FINAL DEVELOPMENT PLAN APPLICATION

| Project/Property Address or Location: 4300 Cherry Bottom Road | | Project Name/Business Name (if applicable): Columbus Academy - Athletic Facilities Renovation | |

RE: Project 4300 Cherry Bottom Rd Final Development Plan

PLANNING AND DEVELOPMENT STAFF REPORT

DRAWING NO.
C100

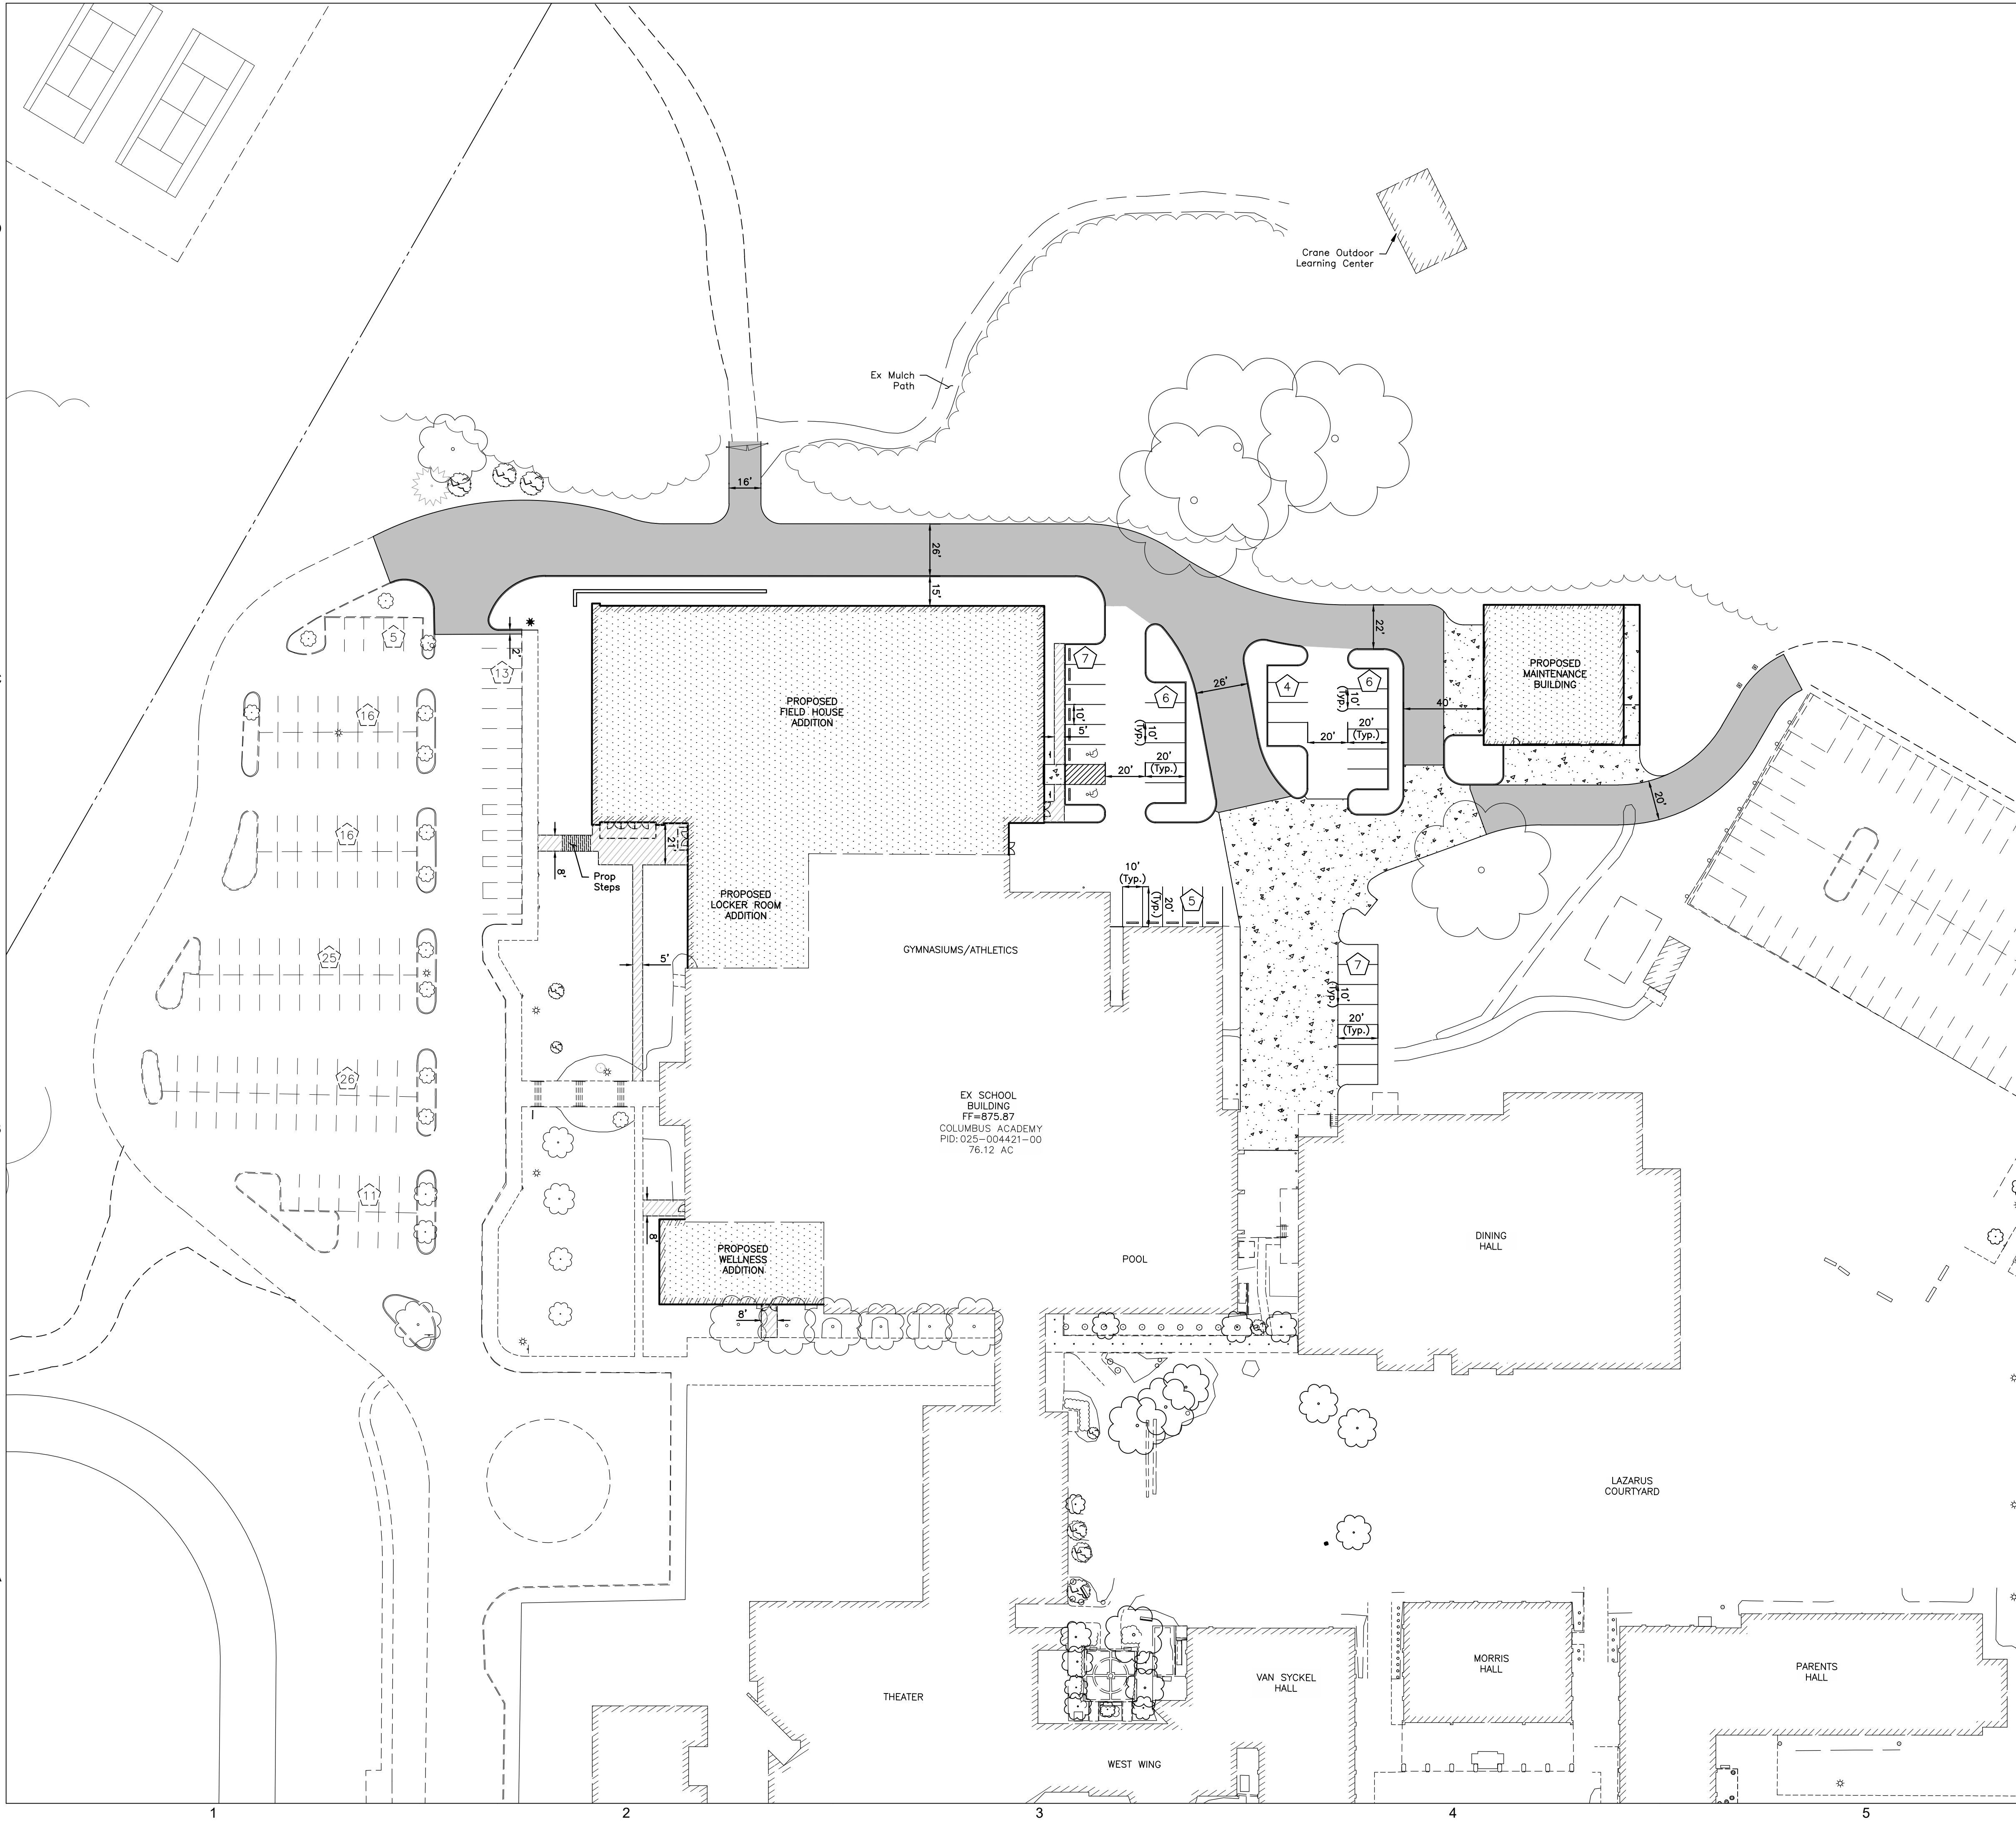
4. Based on the increased square footage of the gymnasium and the maintenance garage, approximately 452 additional parking spaces are required. No issues with those being located elsewhere on the property but please confirm that a sufficient number of spaces exist.

5. Chapter 1163.07 requires two handicap spaces based on the addition of 35 new spaces. Please revise accordingly.

Response: The field house is an improvement/addition to amenity spaces that support activities that already exist on campus. This amenity will not increase the

enrollment, assembly, or traffic from the existing condition. There are no bleacher or seating systems proposed in the field house. However, the spaces required per code are readily available elsewhere on the campus. Over 150 spaces are immediately adjacent to the project with approximately 500 spaces total on the campus.

Response: ADA spaces have been added to the site.
